Access Compliance Report Public Rights-of-Way (Pedestrian Signals)

Main Street: YORBA_LINDA_BLV Cross Street: YORBA_LINDA_BLV Location: NW

ADA ID: SGAT220221103115 Signal Type: One Push Button-Non APS Overall Compliance: No Severity Scores: BTN 1: 35 BTN 2: N/A No BTN: N/A

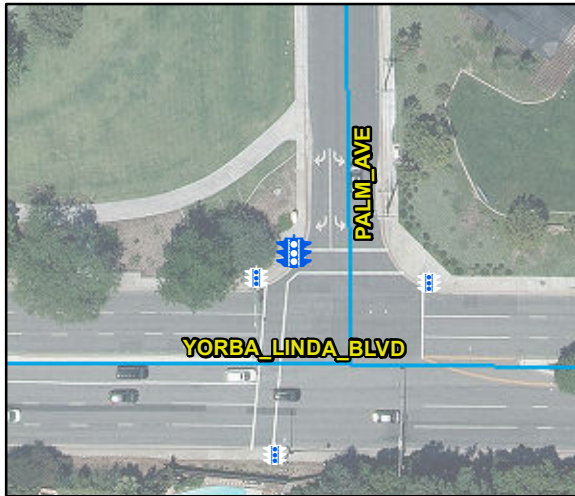
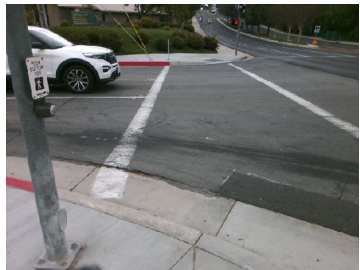
Possible Solutions: Replace Signal Push Button With APS Button. Remove and Replace Clear Space.

OC Std/PROW: R404.2, R404.3, R403.4, MUTCD 4e.08
